LuK Service Info

Part Nr. 331 0075 12 – 310MM TDCA

Model: 856XL, 856XLA, 955XL, 956XL, 956XLA, 1055XL, 1056XL

TB1259

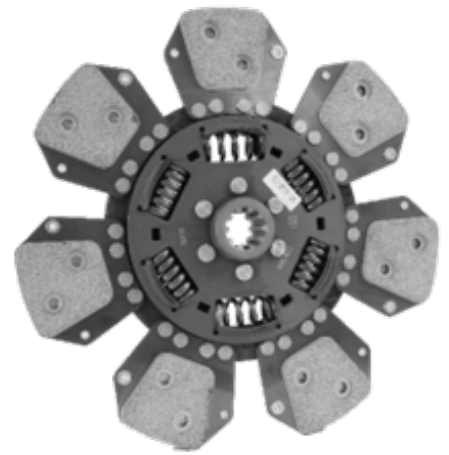
331 0075 12 replaces / ersetzt /
remplace / sustituye a / sostituisce
331 0075 11

631 1364 19 = 231 0023 16 + 331 0075 12

631 1364 11 = 231 0023 16 + 331 0075 12 + 500 0398 40 + 500 1292 40 + 410 0026 41
